ENVIROCARE OF UTAH, INC.
THE SAFE ALTERNATIVE

March 6, 2000

Overview

11e.(2) - Selection of Metals Compliance Parameters

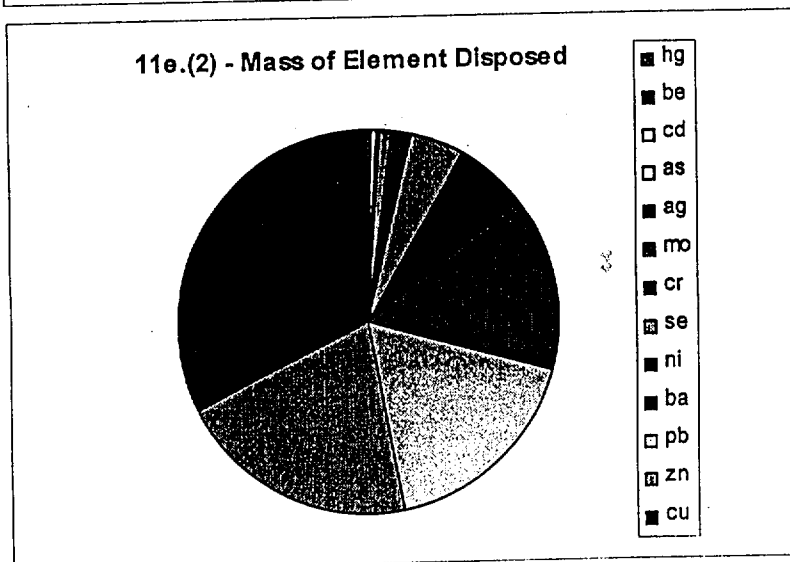
- Approach appears to be acceptable, but Kd values are an unknown. May have to either do a literature study on the affects of high TDS on Kd or conduct site specific Kd studies. Concern is that the Kd values proposed may vary by several orders of magnitude.

- Conduct literature search to do a qualitative evaluation as to the affects of high TDS waters on Kd.
- Prepare final report on hanging the monitoring network to include the following:
 - Use only Lead, Copper, and Zinc as compliance parameters
 - Continue to use Uranium, Thorium, and Radium as compliance parameters
 - Sample for Volatiles and Semi-volatiles on an annual basis
- Conduct lab study to do a quantitative evaluation as to the affects of high TDS waters on Kd.
